Application for Licence Amendment

Licence Number	L8937/2015/1
Licence Holder	Pilbara Ports Authority
ACN	94 987 448 870
File Number	DER2015/002837-2~9
Premises	Utah Point multi-user bulk handling facility Portion of Lot 600 on Deposited Plan 407880 PORT HEDLAND, WA 6721 Certificate of Title Volume LR3173 Folio 502 As defined by the Premises maps attached to the Revised Licence
Date of Report	13 September 2023
Decision	Revised licence granted

Figure 1: Indicative FEL load paths with the additional fixed hopper location

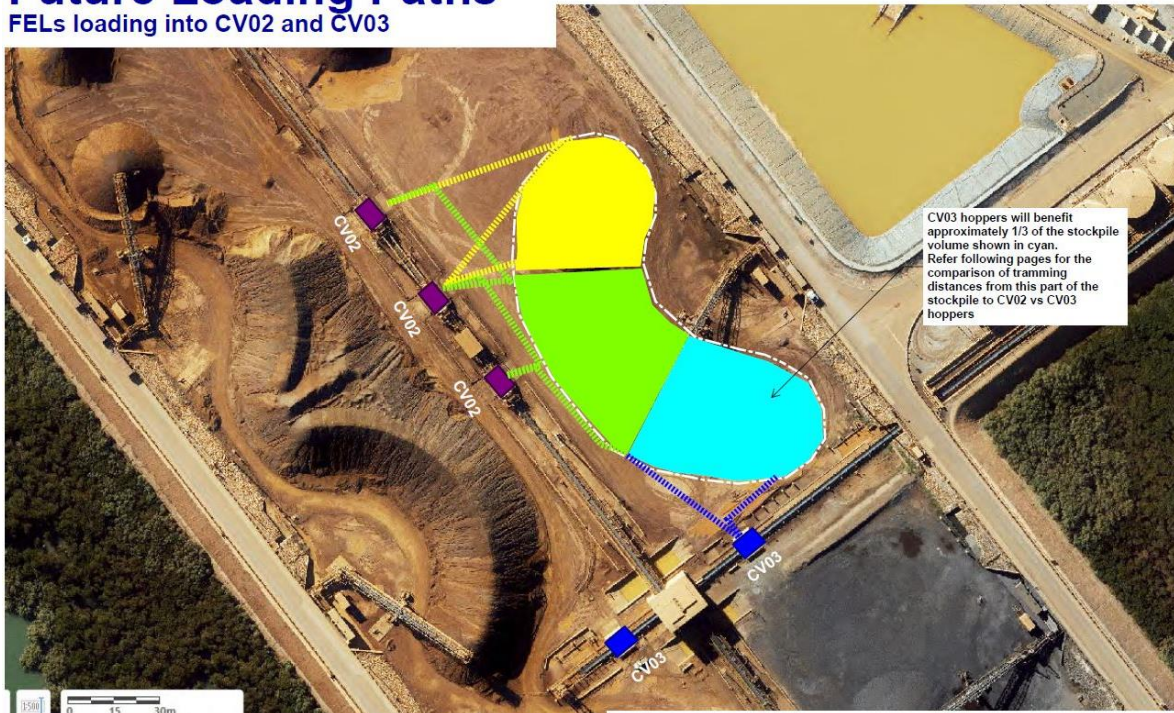
The Licence Holder provided an analysis of tramming efficiency of the proposed changes against existing operations (proposed loading paths and tramming distances) to indicate that the new fixed hoppers would reduce tramming distance for FELs loadout activities (Figure 1).

Figure 2: Load path efficiencies with the additional fixed hopper location

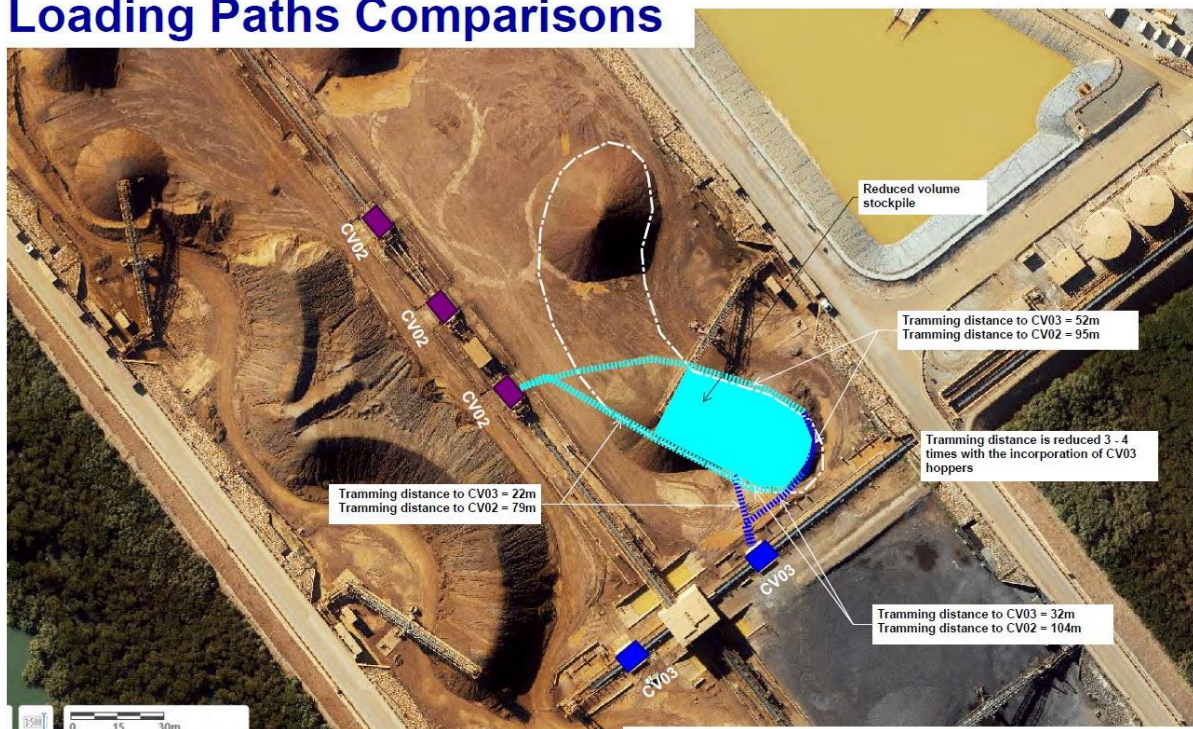
A review of loading path comparisons provided by the Licence Holder indicate that for one third of the stockpiles (stockpiles 2, 3, 10 and 11) located closest to the proposed fixed feed hopper, traming distance is significantly reduced (Figure 2).
